Notice of Allowability	Application No.	Applicant(s)	
	10/626,491	JAUSSI ET AL.	
	Examiner	Art Unit	
	Terry L. Englund	2816

EXAMINER'S AMENDMENT

AMENDMENTS TO THE DRAWINGS

REPLACEMENT SHEET
 Page 1 of 6
 FILTERING VARIABLE OFFSET AMPLIFIER
 James E. Jaussi et al.
 10/626,491
 10559-534002

FIG. 1

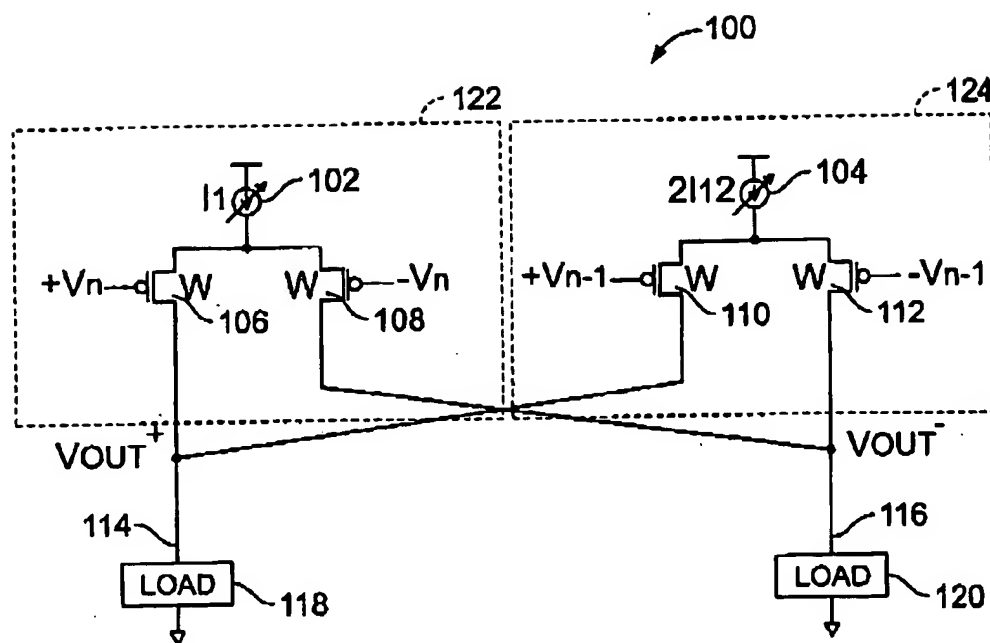
In Figs. 1-5, the Applicants have added labels to identify V_{out+} and V_{out-} .

FIG. 2

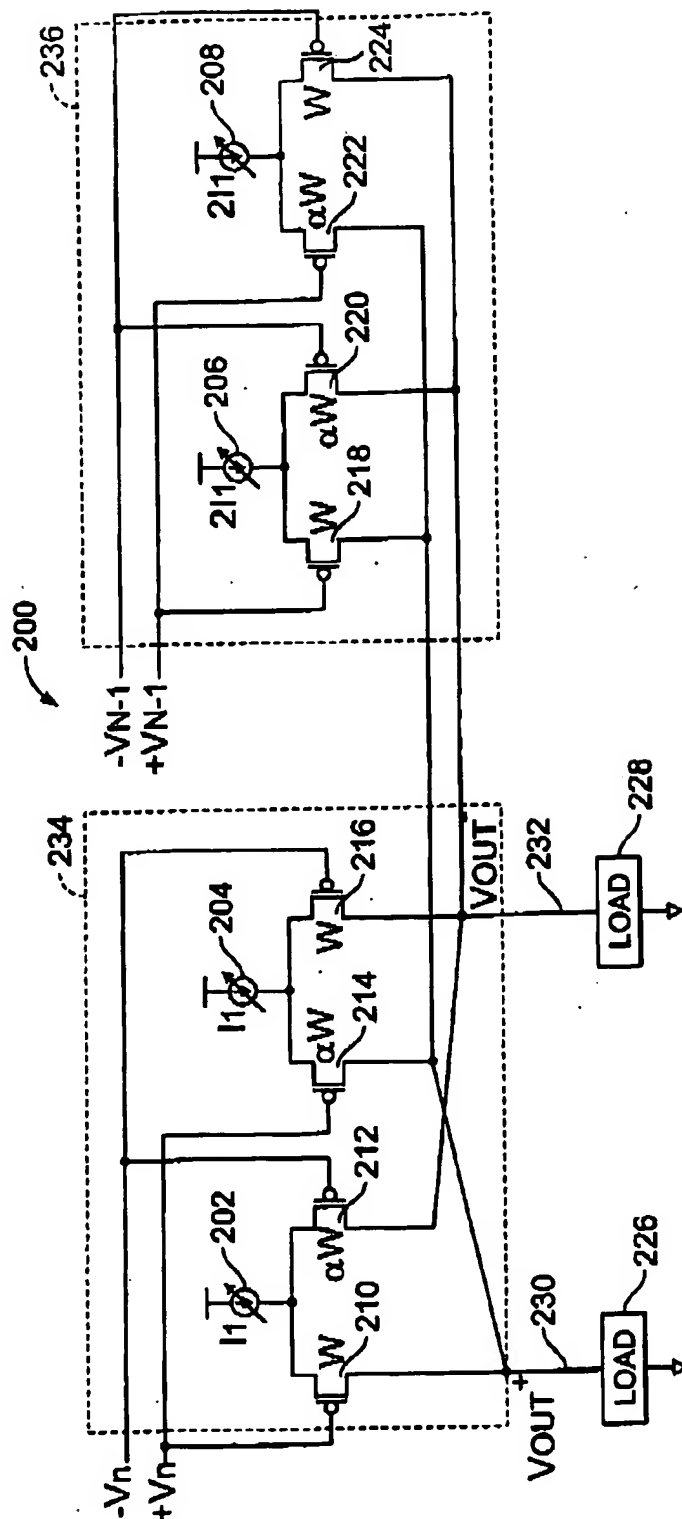
In Fig. 2, the Applicants have shown the configuration described in the specification by swapping the inputs labeled V_{N-1+} and V_{N-1-} .
